CPSL PROJECT NO. P22-143-A1  
 PLSUSD PROJECT NO. 5327

**DRAGONFLY INDUSTRIAL PARK**

**OVERALL SITE PLAN**

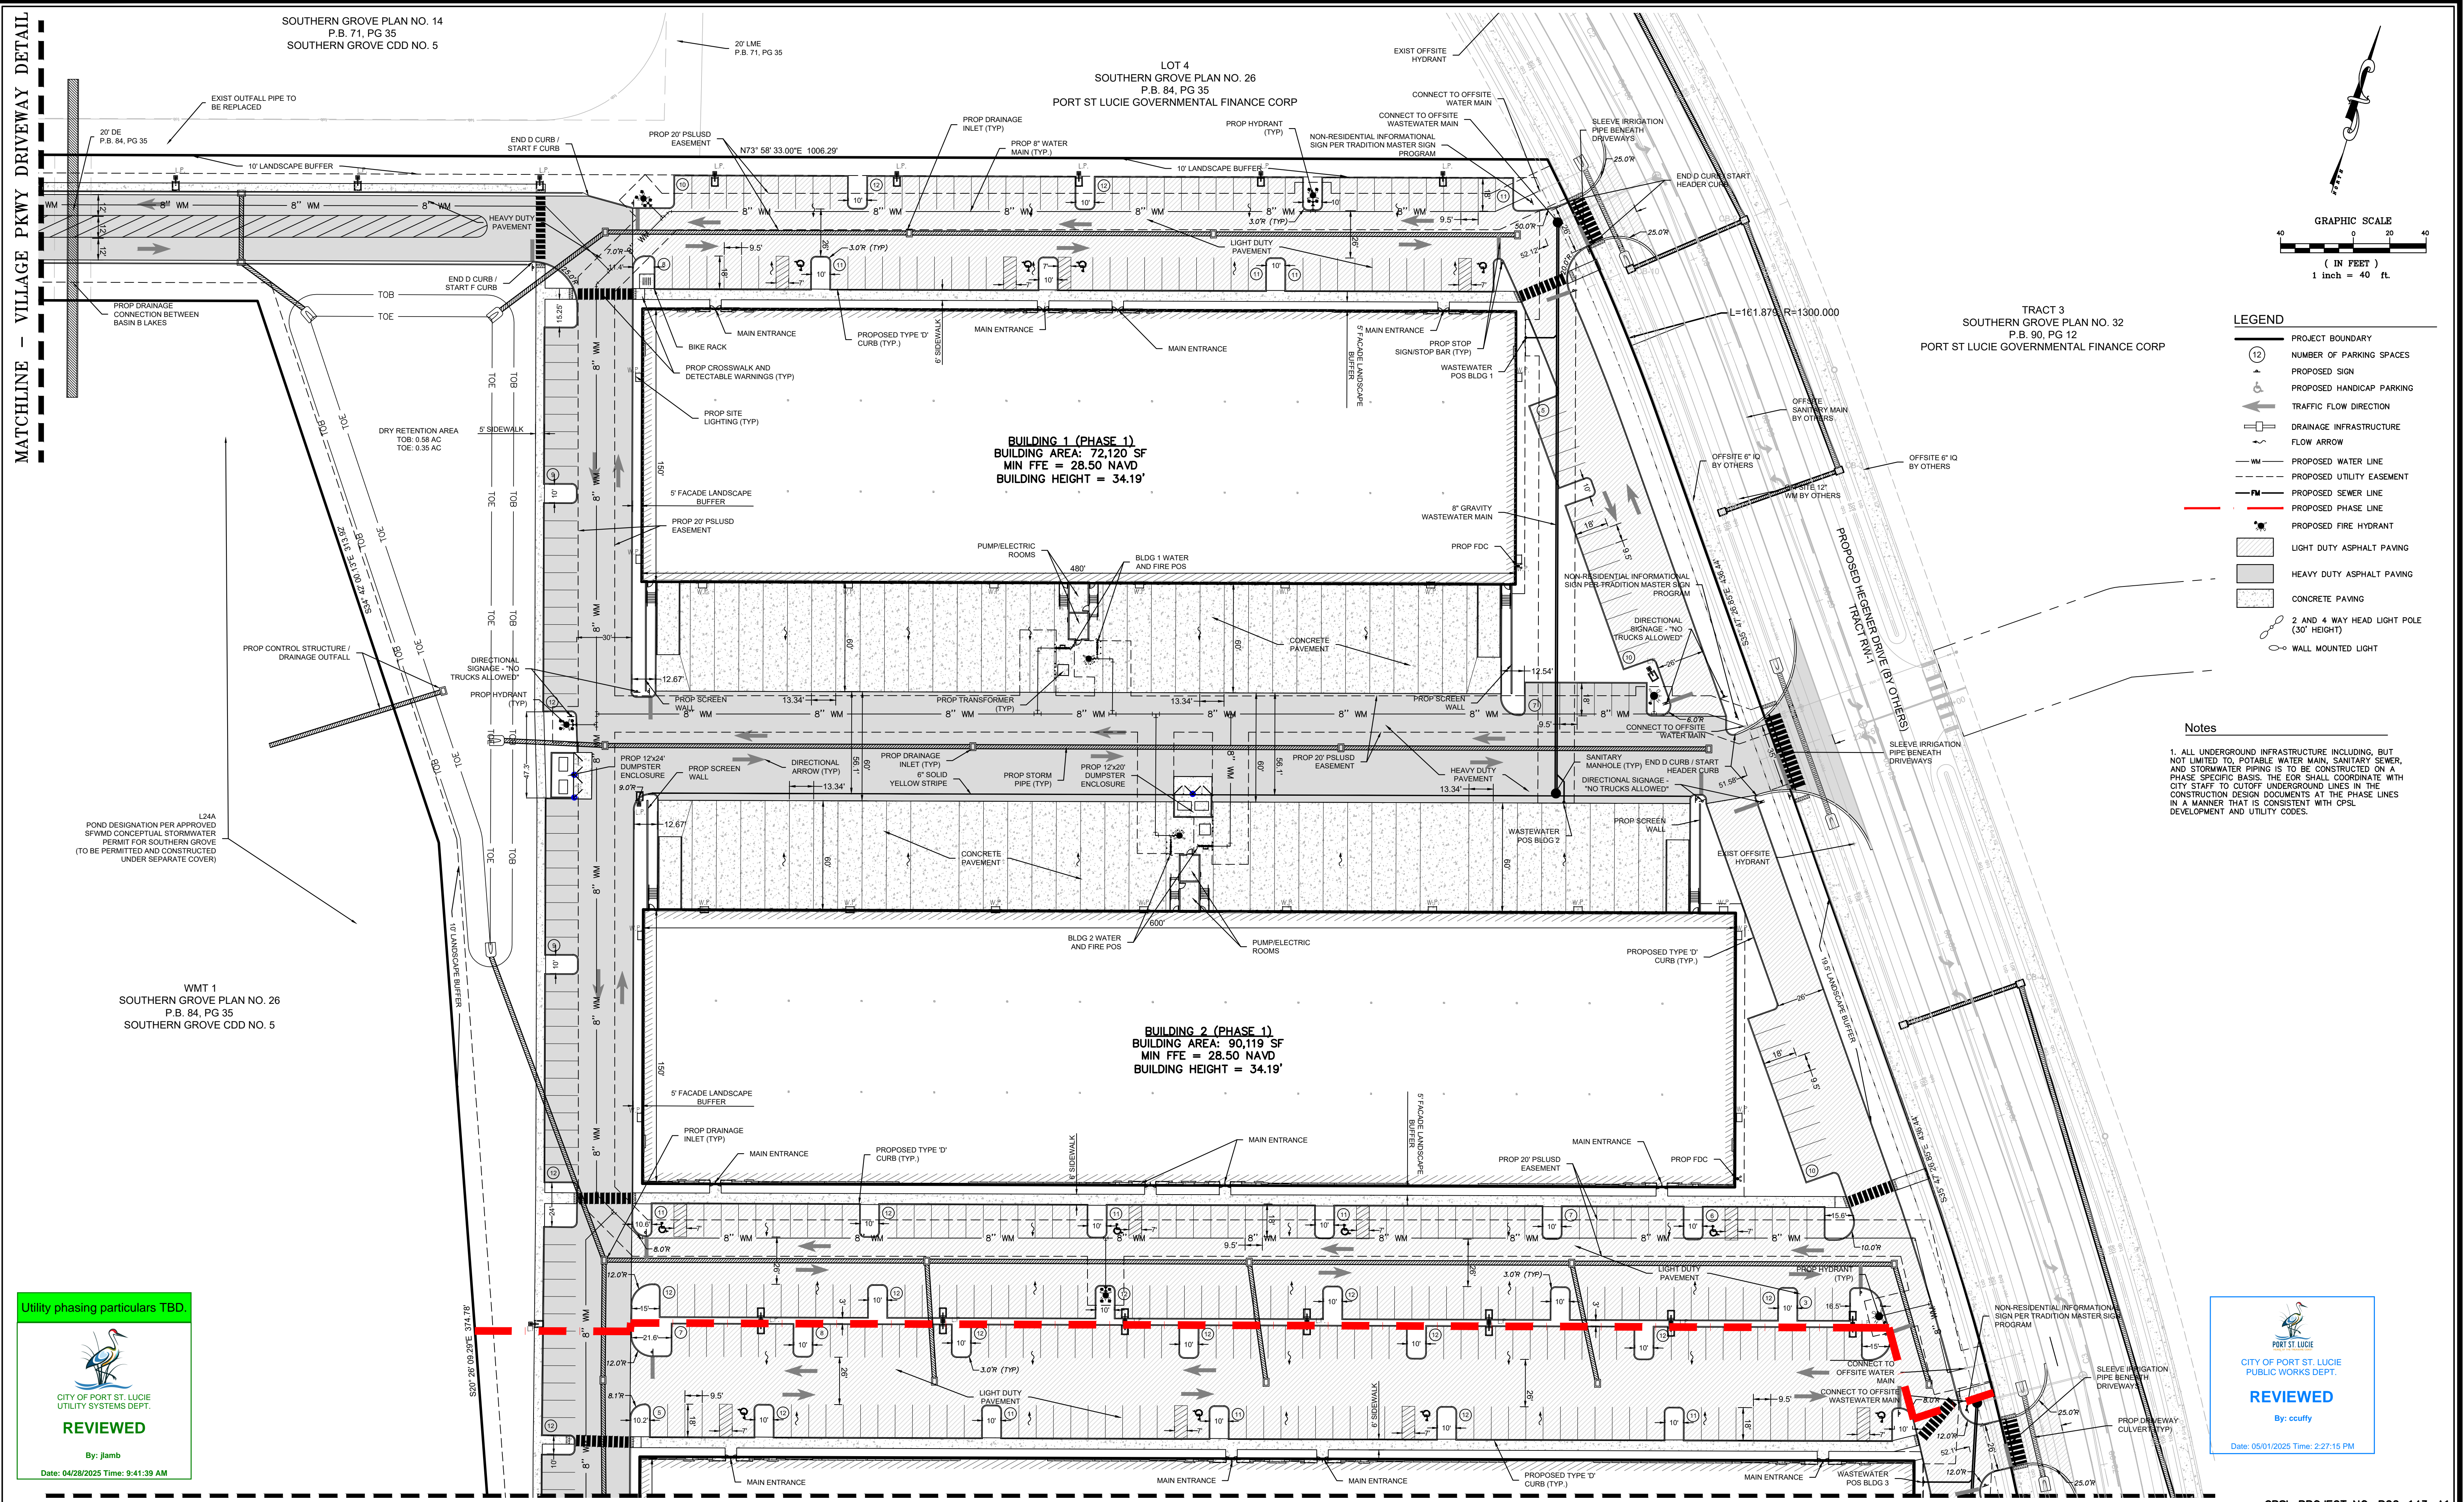
**Utility phasing particulars TBD.**

**DETAILED SITE PLAN**

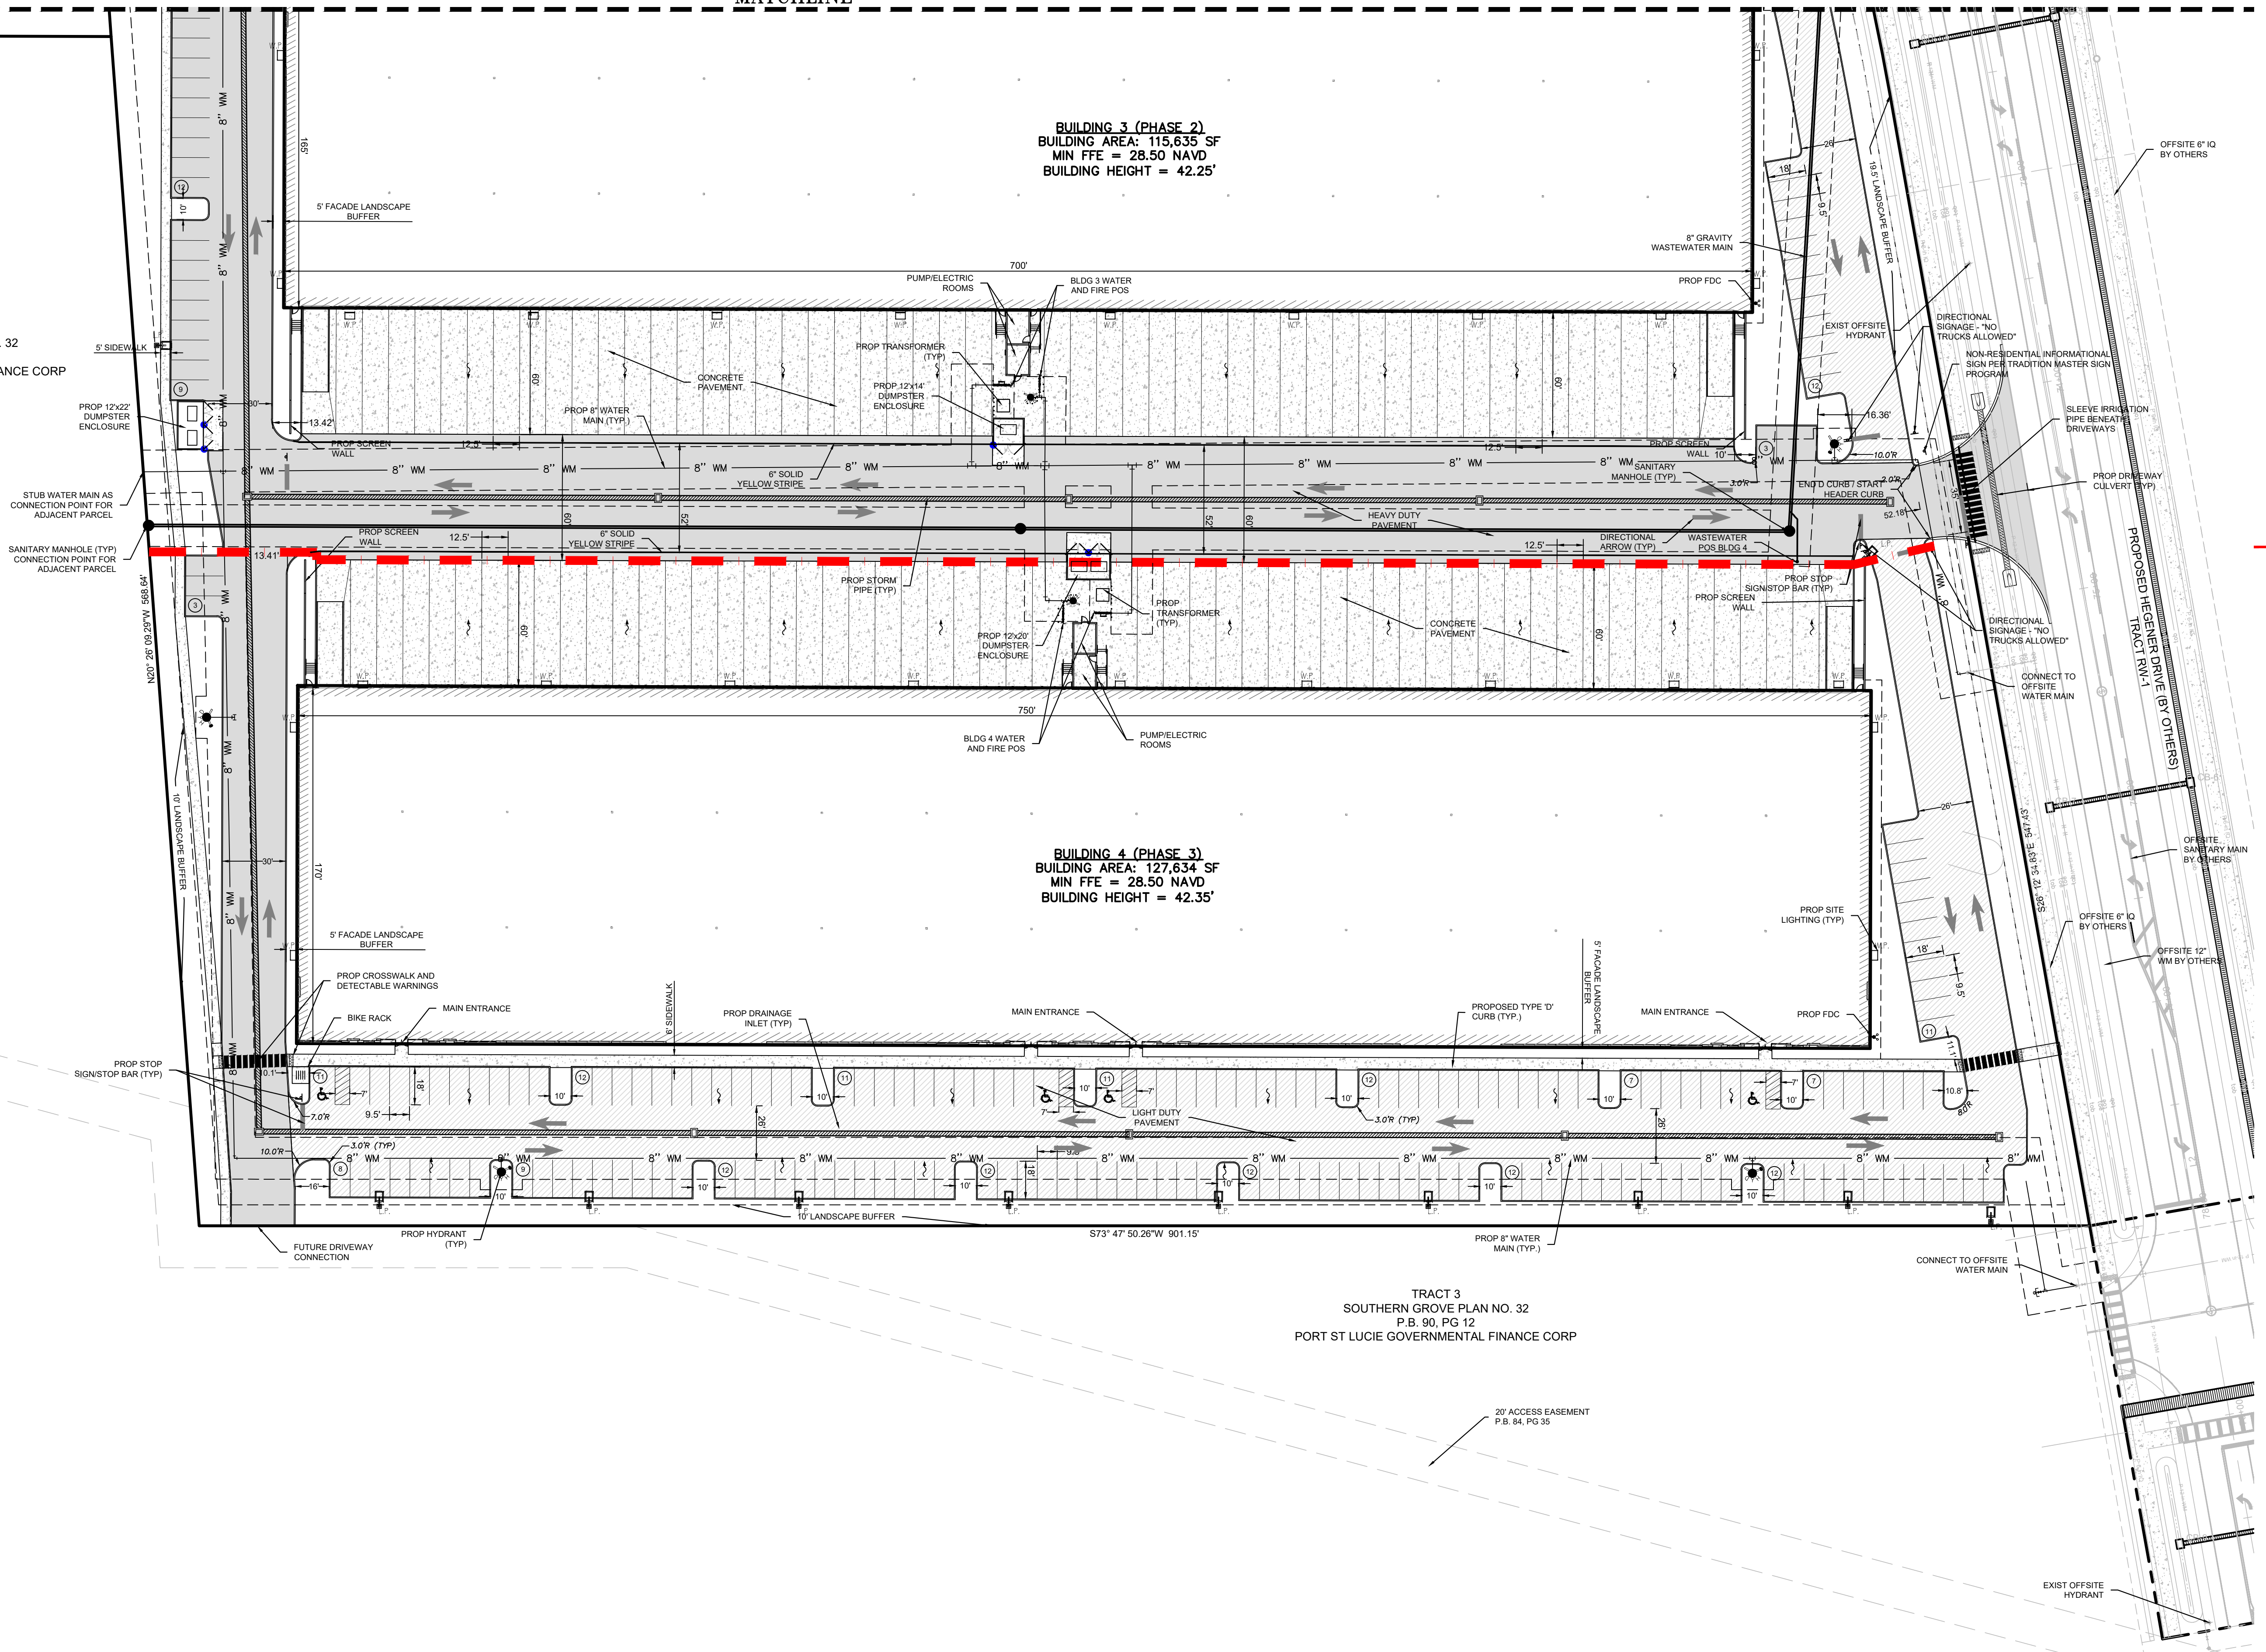
Utility phasing particulars TBD.
